**SAFETY EVALUATION REPORT
WORK PLAN FOR REMEDIATION TO UNRESTRICTED USE OF THE AAR SITE, WESTERN
PARCEL (INKSTER ROAD, LIVONIA, MICHIGAN)
DOCKET 040-00235**

December 30, 2013

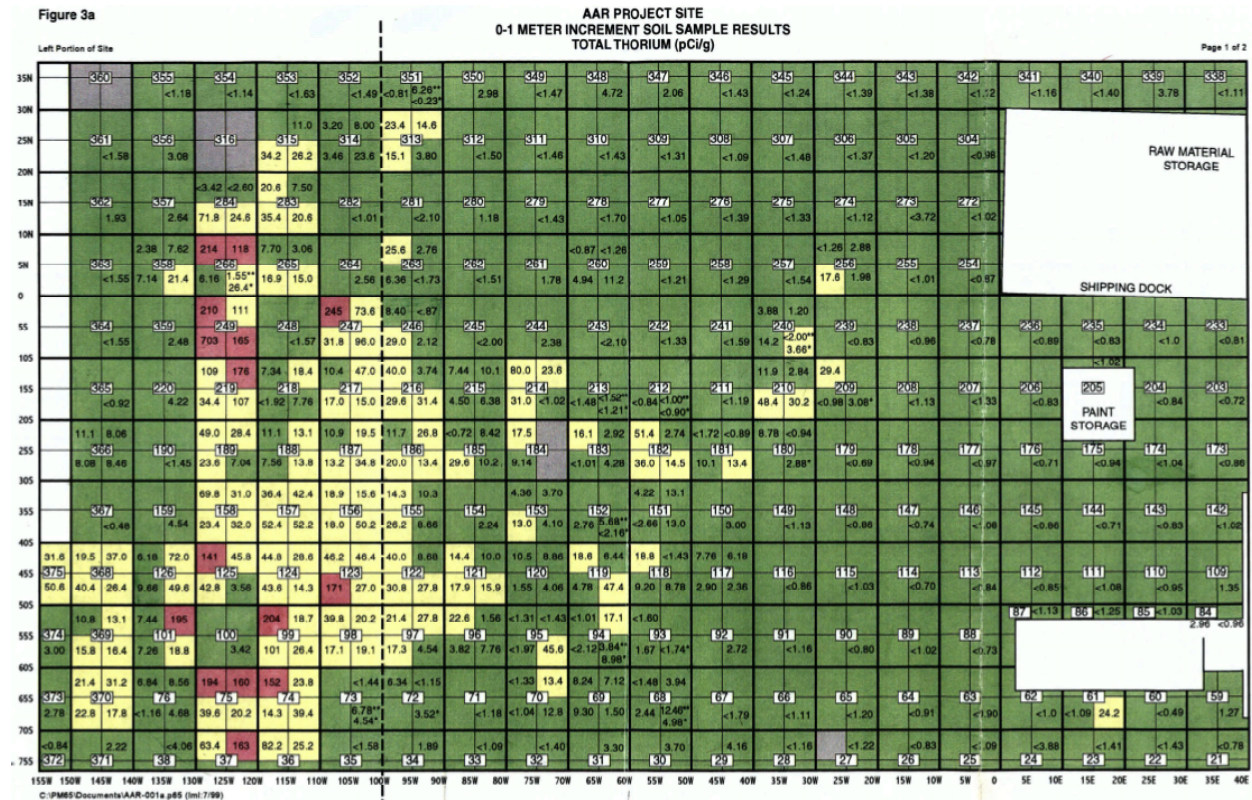
The AAR site at 12633 Inkster Road, Livonia, Michigan, was legally divided into the Eastern Parcel and the Western Parcel. The Western Parcel is that part of the site west of the 100W grid line of the site coordinate system (see Figure 1). As indicated by the locations of proposed excavations, the Work Plan addresses excavation of residual radioactive material primarily from the Western Parcel, but also from the Eastern Parcel near the Western Parcel. In addition, for purposes of evaluating potential dose and acceptability of the remaining residual radioactive material, AAR averages residual radioactivity concentrations over the Western Parcel and part of the Eastern Parcel. Thus, the Work Plan in actuality addresses that part of the AAR property that is west of gridline 60W (see Figure 1). For the remainder of this Safety Evaluation Report (SER), *the NRC staff considers the Western Parcel to be all the area west of gridline 60W.*
